# County of Santa Cruz<sup>0181</sup>

## PLANNING DEPARTMENT

AGENDA: September 19, 2000

Subject: APN: 044-301-08  
Lands of Wickum, 229 Augusta Lane, Aptos, CA  
Rio Highlands Subdivision

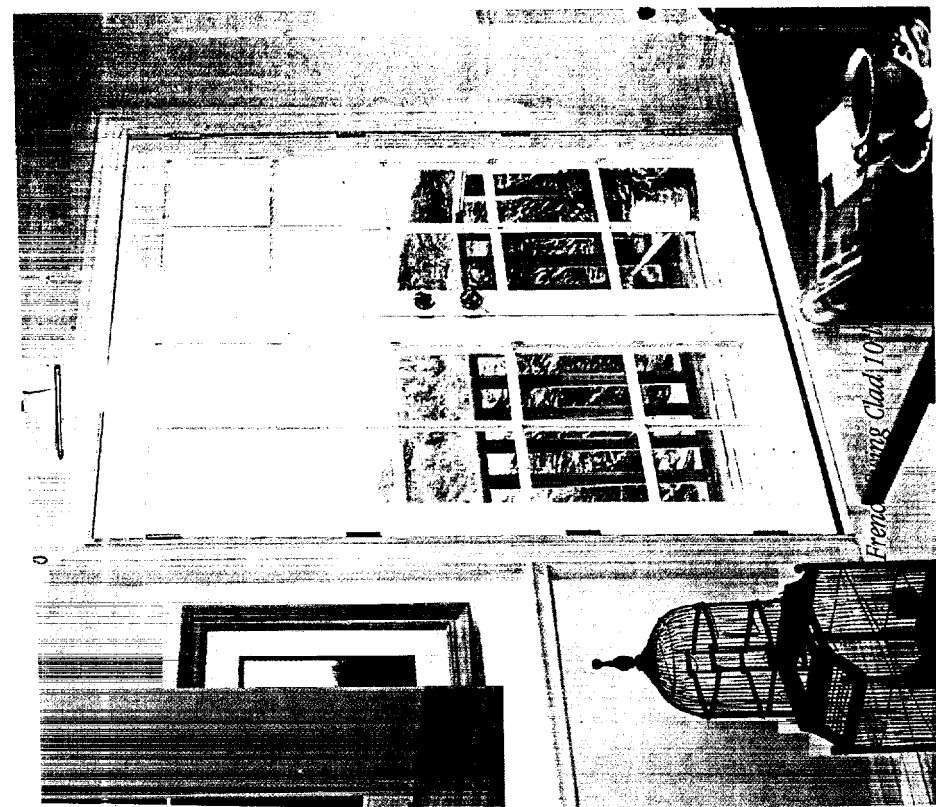
The owners of Lot 8 of the Rio Highlands Subdivision have submitted a request to install a French Door on the south facing wall (street side yard) to provide an access to a proposed patio area. This wall faces out to Rio Del Mar Blvd. Staff has evaluated the request and finds that it is in keeping with the original Conditions of approval (Condition II E. 3.) in that no new window/ door is being placed on the rear facing yard (Meadowlark ) or on the second floor, is similar to the other lots which have frontage on Rio Del Mar Blvd. and will not negatively impact any neighboring property.

It is therefore RECOMMENDED that your Board approve this minor change to the building design for lot 8 of the Rio Highlands Subdivision.
